July 22, 2011

RE: PORTAGE COUNTY
CITY OF AURORA
SAGINAW CONTROL BUILDING ADDITION
CONSTRUCTION STORM WATER

Figure 3 – Much of the site lacks stabilization.

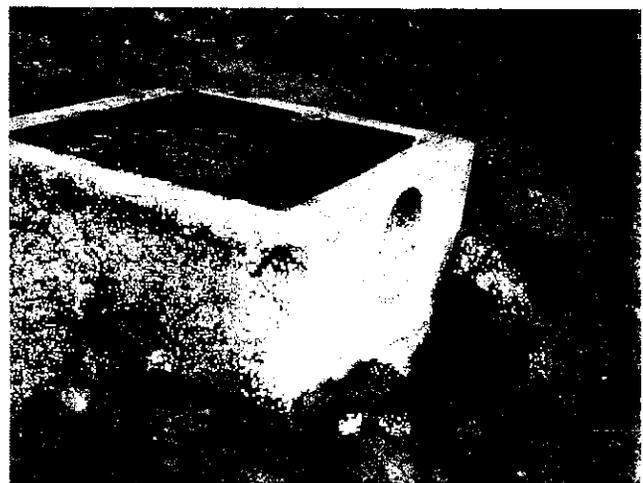
3. Much of the site lacks stabilization, especially the area surrounding the pond on the west side of the building. If any portions of the site have reached final grade, you must permanently stabilize these areas within 7 days. In addition, if earth-moving activities will not be conducted in other areas within the next 21 days, you must temporarily stabilize these locations within seven days of the last earth disturbance.
